North Mining Limited

Northparkes Mines

Section 75W Submissions Report

July 2009

Supporting noise information

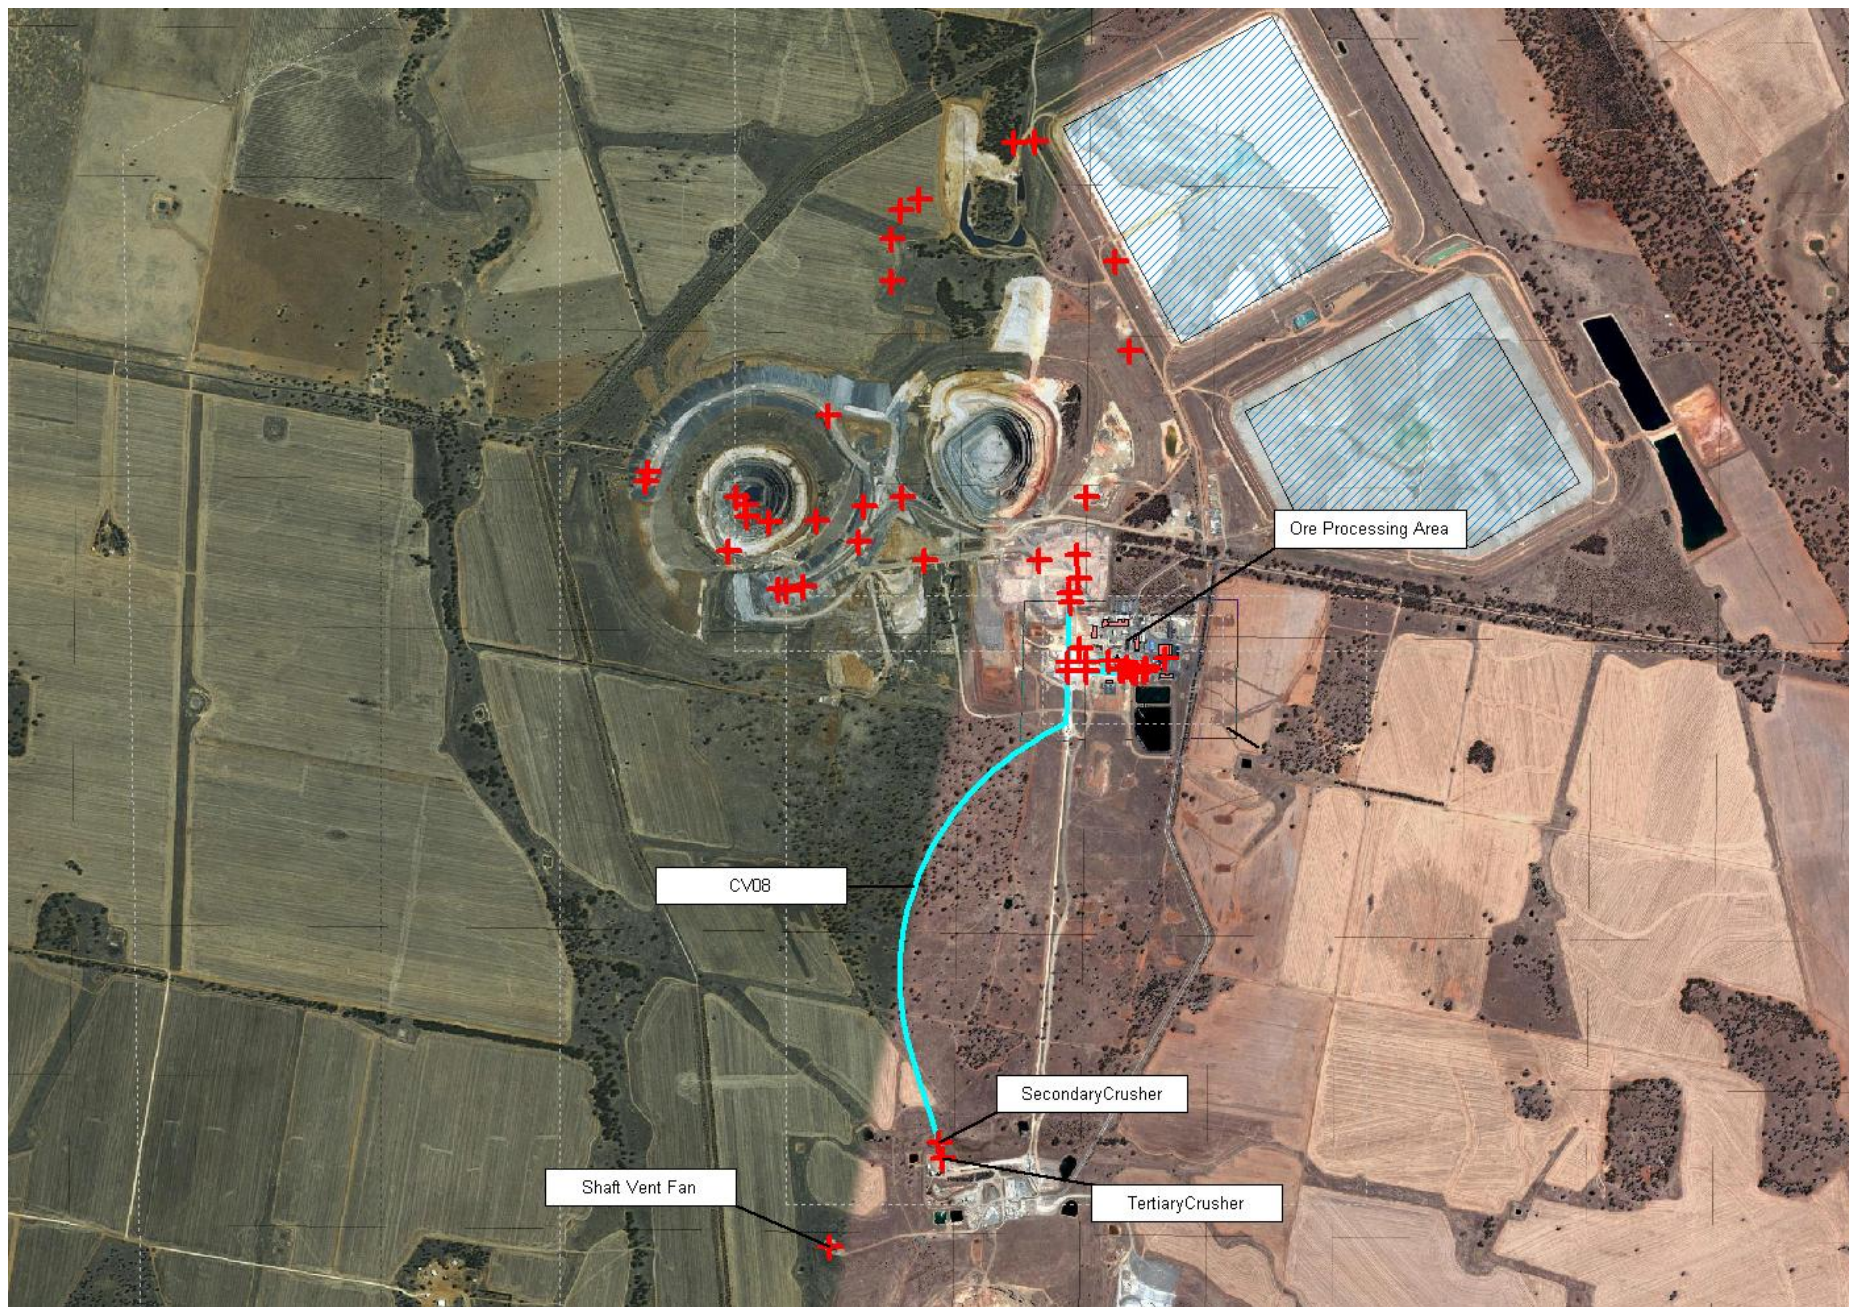
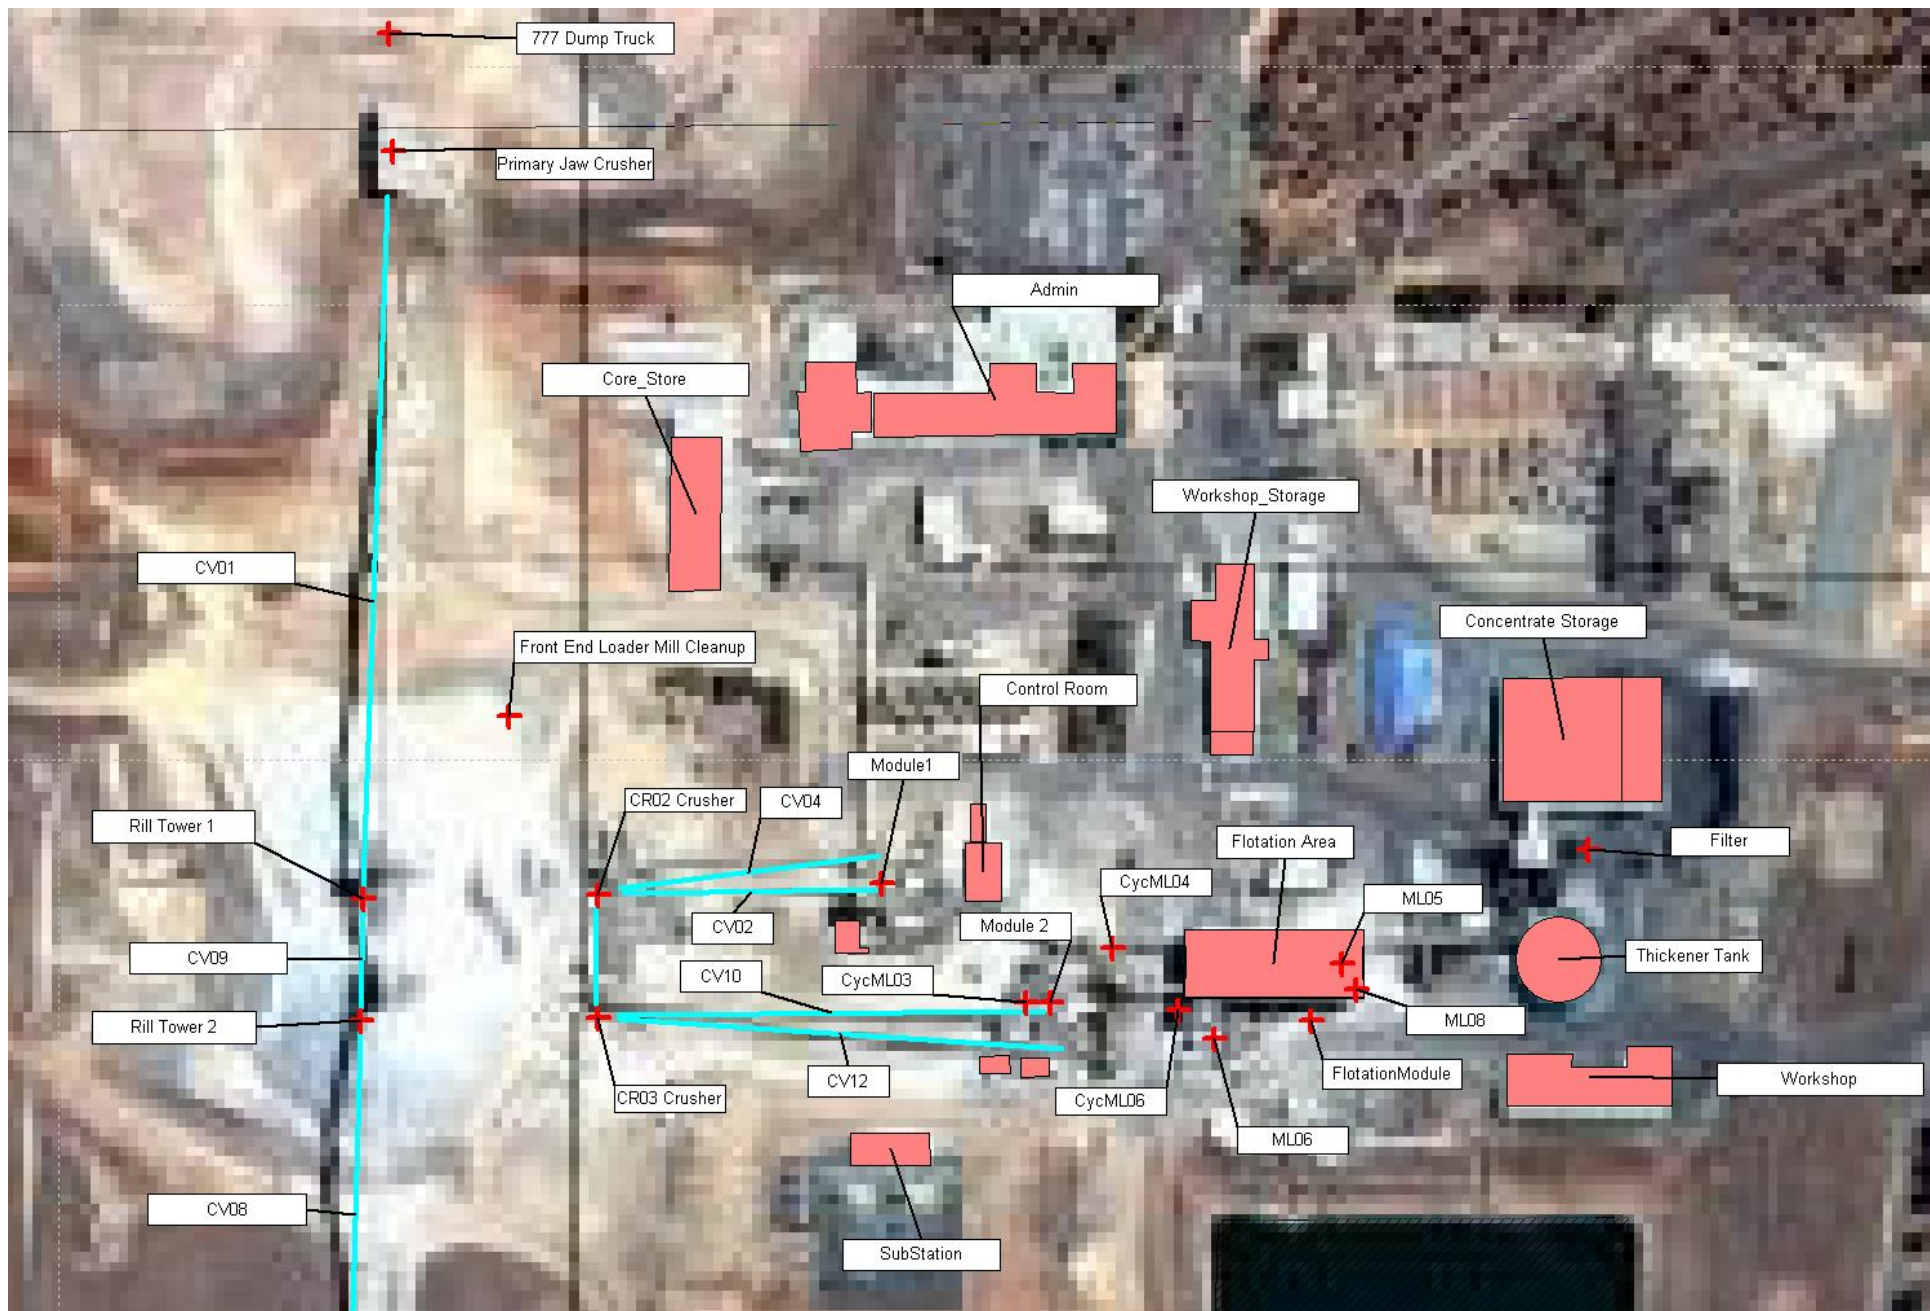
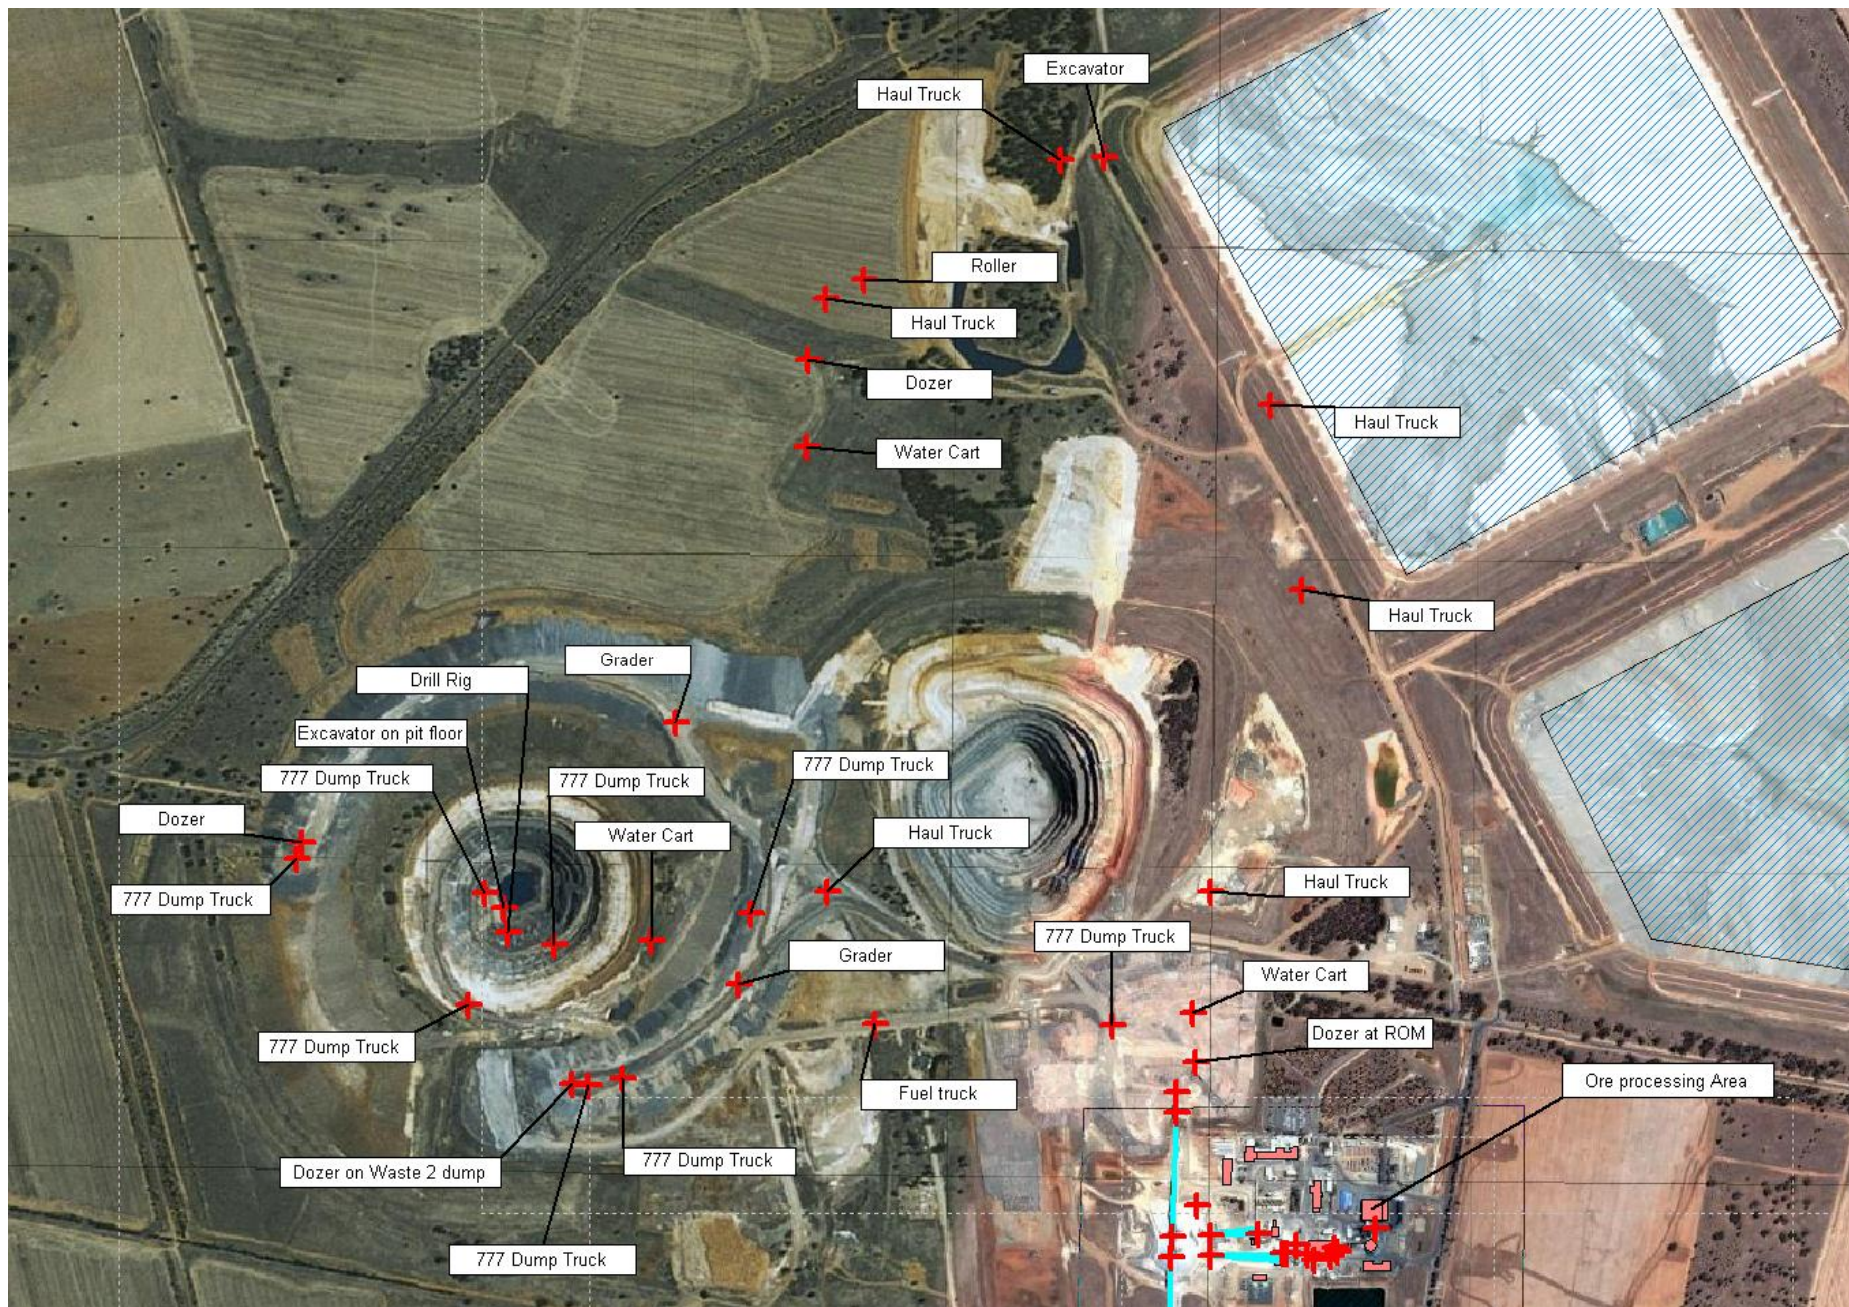
- 3. NPM must provide a figure in the Noise Impact Assessment (NIA) detailing the mine site and the surrounding topography out to as far as the nearest affected receivers with the location of mobile and stationary plant and equipment in the noise model superimposed.*

3. Figures are provided in Appendix B.
4. All references in the EA to DECC Construction Noise Guidelines were noted as "Draft for consultation".
5. The original NIA used the Draft Construction Noise Guideline because the Estcourt TSF construction is not part of the typical operational noise for NPM and therefore was not considered as operational noise. The NIA was reviewed against both the Draft Construction Noise Guideline and chapter 171 of the DECC Environmental Noise Control Manual (ENCM). This revealed that the construction noise criterion is identical, i.e. background + 5dB = 35 dB(A). Therefore the criteria would remain the same if the ENCM was used instead of the Draft Construction Noise Guideline as required by DECC.
